BEAM 2B1 - SOLID GLOB LAM 3" x 15 3/4"

Ref: 240 Canterbury Arbitration – Calculations
Job #1954

CPH
240 CANTERBURY
AUSTIN TX

2ND FLR FMG.

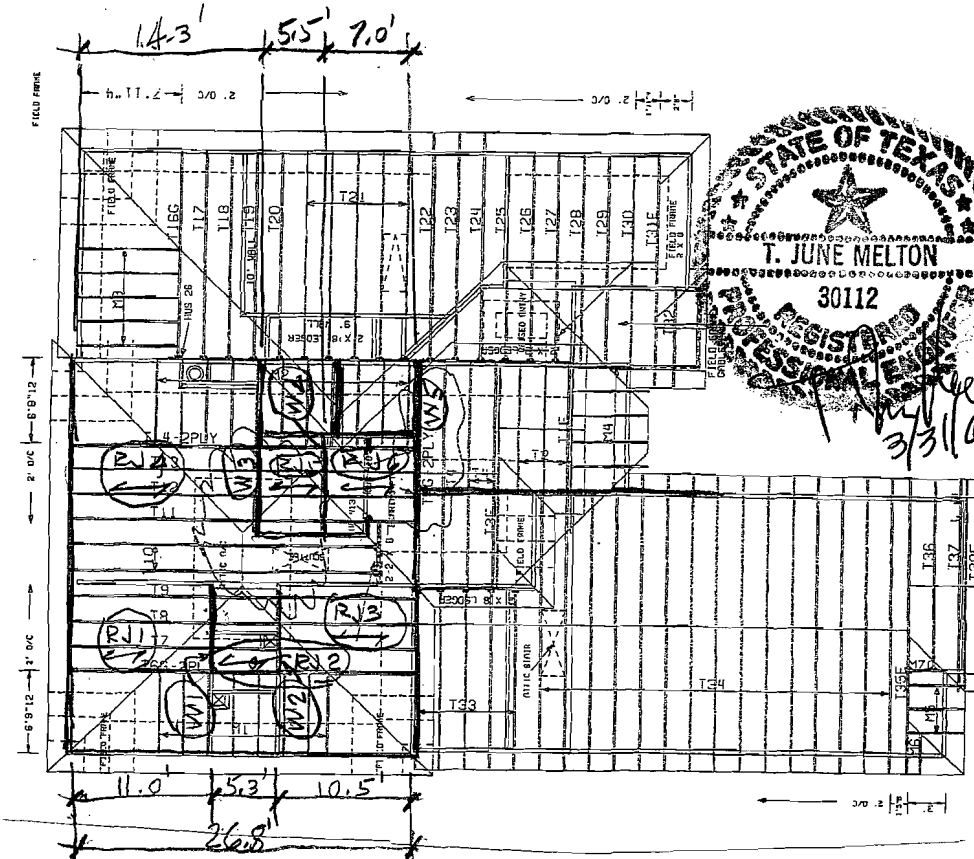
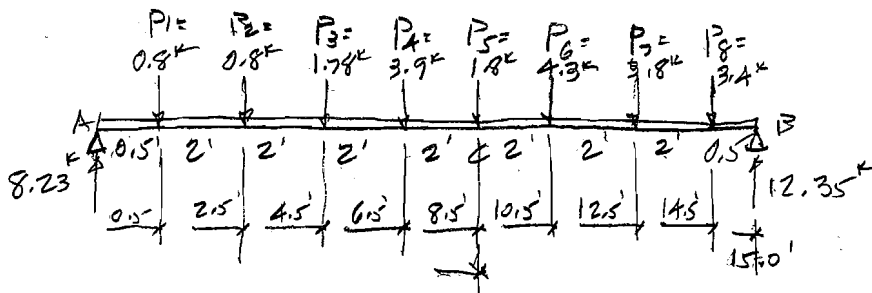
$$P_1 = 0 + (390)(2) + 20 = 800 \#$$

$$P_2 = 800$$

$$P_3 = (490)(2) + (390)(2) + 20 = 1780 \#$$

$$P_4 = (490)(2) + (390)(2) + (300 \#)(7') + 20 = 3880 \#$$

$$P_5 = (490)(2) + (390)(2) + 20 = 1780 \#$$

$$P_6 = (490)(2) + (350 \#)(9')(0.8) + (390)(2) + 20 = 4300 \#$$

$$P_7 = (490)(2) + (290)(7) + (390)(2) + 20 = 3810 \#$$

$$P_8 = (490)(2) + (230)(9')(0.8) + (390)(2) + 20 = 3440 \#$$

CONNECTOR REACTIONS	
ZJ1	ZJ2
0	780 #
0	780 #
980 #	780 #
980 #	2880 # N.G. FZ
980 #	780 #
3500 # FS N.G.	780 #
980 #	2810 # N.G. FZ
2640 FS N.G.	780 #

$$\begin{aligned} \sum M_c &= -(4.3)(2) + (3.8)(4) + (3.4)(6) - (12.35)(6.5) \\ &= -8.6 + 15.2 + 20.4 - 80.3 \end{aligned}$$

USED SIMPSON JHA413
Rallow = 1940 # FLOOR

$$M_c = 36.1 \text{ k} \quad (433 \text{ k})$$

$$S_{x \text{ req}} = \frac{433}{2.4 \text{ ksi}} = 180.5 \text{ in}^3$$

$$S_{x \text{ FURN}} = \left(\frac{1}{6}\right)\left(\frac{1}{3}\right)(15.75)^3 = 124 \text{ in}^3 \text{ N.G.}$$

EXISTING BEAM IS TOO SMALL

KeyBeam® 4.504a
kmBeamEngine 4.506k
Materials Database 960

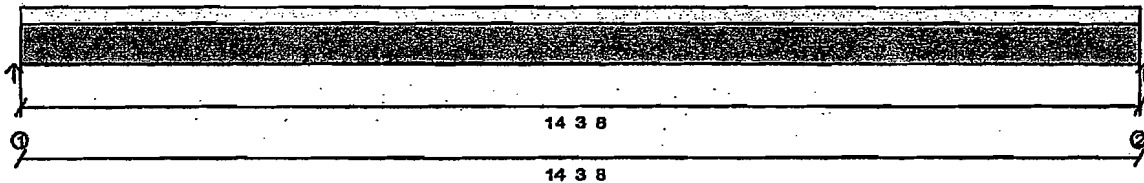
Attached are two computer-generated calculation spreadsheets. Canterbury240A.xls utilizes the center to center bearing point span of 15.0 feet as indicated in my original calculations. Canterbury240B.xls utilizes the span of 14.4375 feet indicated on Bates CPH000187. (Please be aware that the calculations indicated on Bates CPH000187 are incorrect insofar as no consideration has been shown for the second floor load bearing walls). Regardless of calculation method utilized, the beam furnished is overstressed and therefore too small and it must be replaced.

There is one other point I should point out. Neither of the span lengths I have indicated in the calculations can be used in the design of a replacement beam. As a result of the misalignment of the beam with the grade beam in the concrete foundation during the original construction, the length of the replacement beam will need to be increased in order to reach the exterior wall top plates as I testified to earlier. That will require a larger replacement beam.
